<https://e2e.ti.com/support/data-converters-group/data-converters/f/data-converters-forum/1215281/afe4490-led-supply-query-and-schematic-feedback>

For schematic review, I usually introduce some marker/notation legend first-

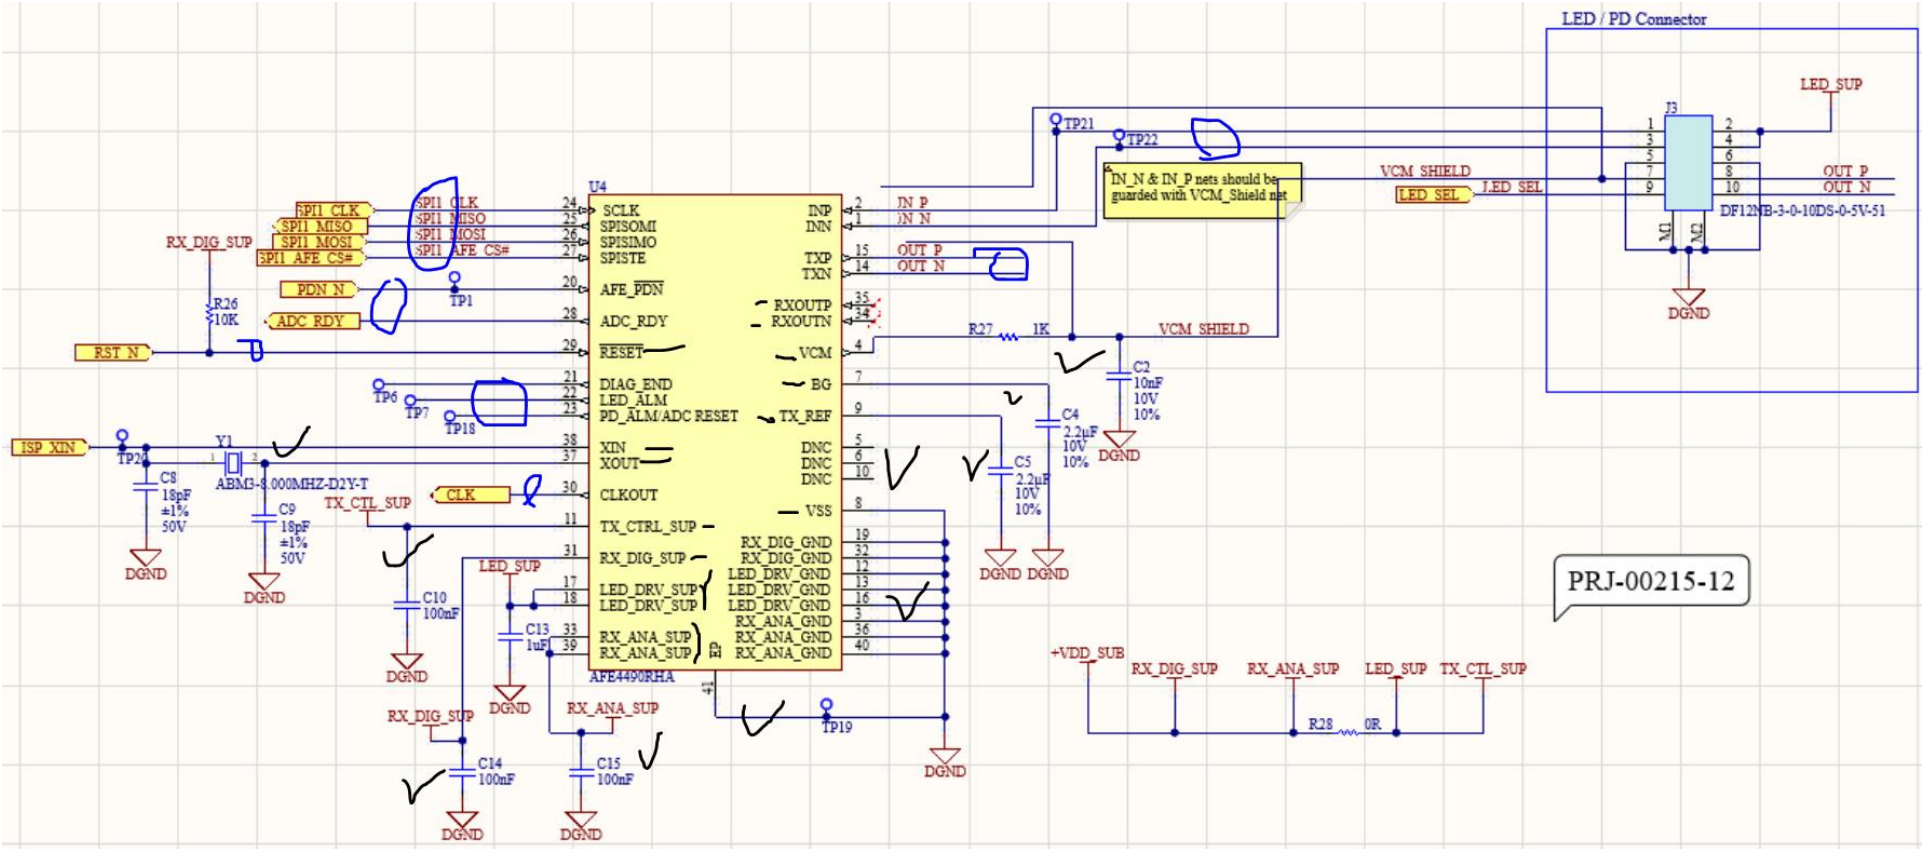
1. Does customer have only DGND as universal GND=ANGD? I think it's ok.
2. TP21,22 consider putting 0 ohm resistors for debugging/troubleshooting if this is prototype board
3. TCP, TXN consider putting 0 ohm resistors for debugging/troubleshooting if this is prototype board
4. Suggest to put TP or 0 ohm resistors along SPI signal lines for debugging/troubleshooting if this is prototype board
5. For CLKOUT, RST_N and PDN_N, EVM has 10 ohm resistor in series, customer may put 10 or 0 ohm for now if this is prototype board
